U.S. Nuclear Regulatory Commission Operations Center Event Report

Event # 49749

PART 21 - LOOSE BATTERY VENT ASSEMBLIES

Subject: Preliminary Notification – Krsko Vent Fitment

Figure 1

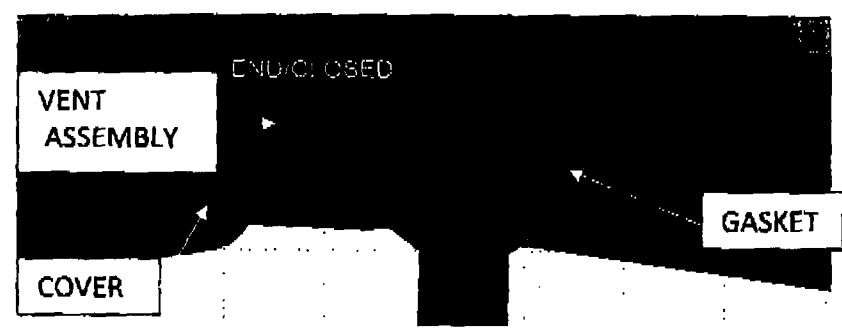
Vent Assembly Installation: The vent assembly has a bayonet fitting. It is inserted into the vent hole on the cover, and twisted to form a seal against the cover. A gasket is used to seal the interface between the cover and vent assembly, preventing sparks or flames from entering the cell. (See Figure 1 for cross section of the assembled seal).

In the case of the NEK batteries the vents were installed, however, there was no resistance when the vent assembly was turned. This indicated that the gasket was not being compressed, and

that there may be a clearance fit that could provide a path for sparks or flames if the vent was disturbed (i.e., during seismic events, etc). A subsequent fit analysis of the LCY cover revealed that there were combinations of gasket, cover, and vent assembly dimensions that may allow clearance fits of up to 0.006", even when all parts were in tolerance. Similar analysis of all other safety related product lines (LCR, LCUN, KCR, 4LCY, DCU) showed that positive seals were present under all combinations of tolerances.

If freely turning assemblies are found, or if the user has any doubt that a seal is being formed C&D will provide thicker replacement gaskets. The user should contact C&D at the numbers below for additional information.
